TOWN OF NEWBURGH PLANNING BOARD TECHNICAL REVIEW COMMENTS

1 POWELLTON AVENUE SITE PLAN (Dr. Paymai)

2015-19

13 NOVEMBER 2015

PROPOSED SITE PLAN

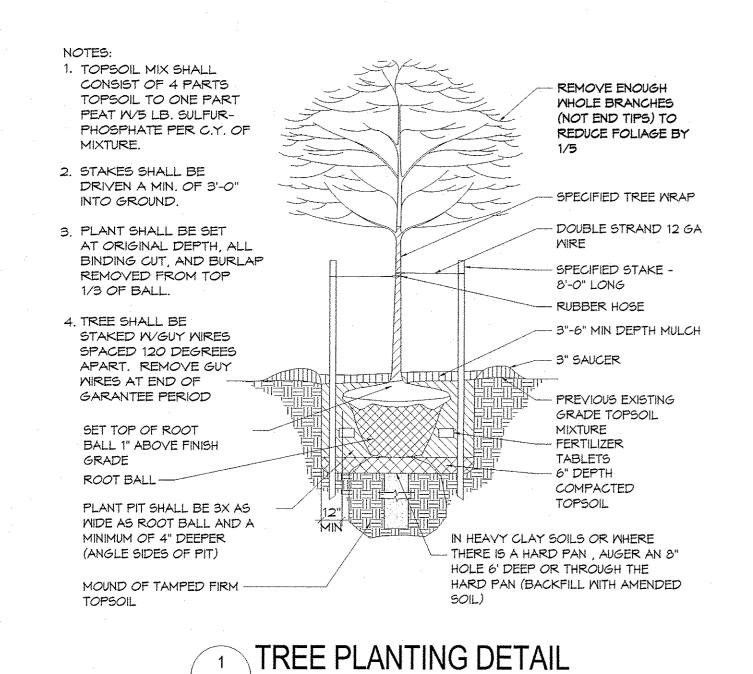
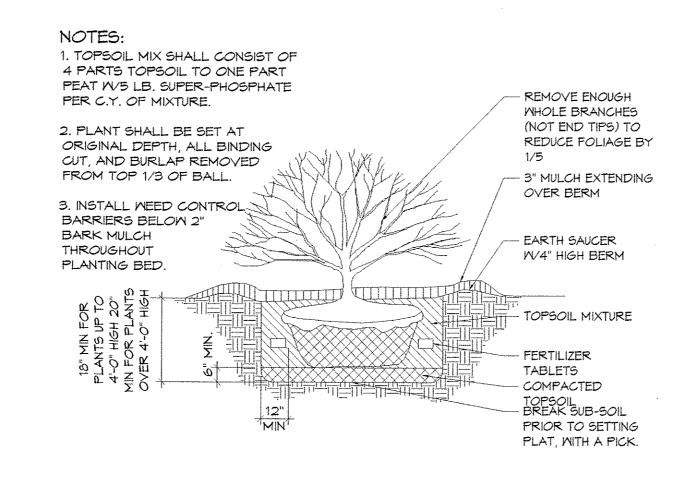
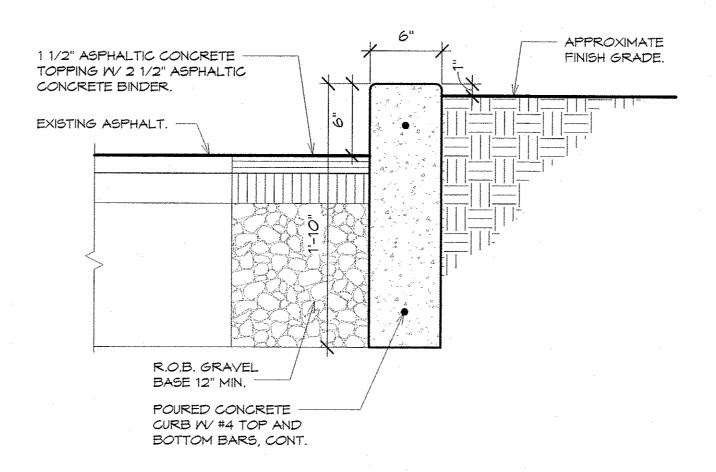
- 7. The Planning Board should discuss potential curb in lieu of bumper blocks proposed on northeast portion of the site.
- Parking lot striping detail in compliance with the Town of Newburgh requirements as well as ADA. Striping details should be added to the plans. ADA striping detail should contain appropriate signage.

3 CURB DETAIL
SP-2 1 1/2" = 1'-0"

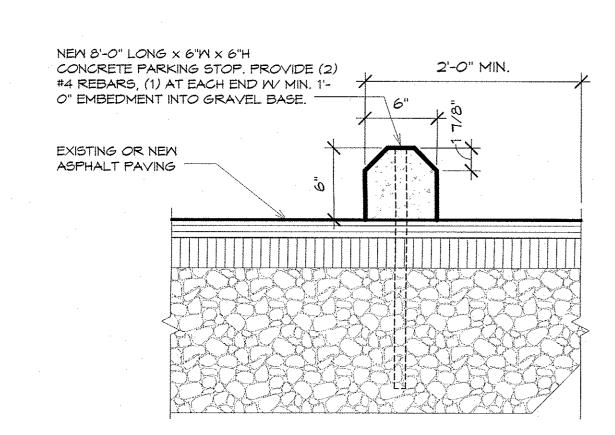
- City of Newburgh flow acceptance letter for increased flow is required.
- Sanitary sewer line location should be identified on the plans. 5.
- We would recommend the concrete curb detail have a stone foundation.
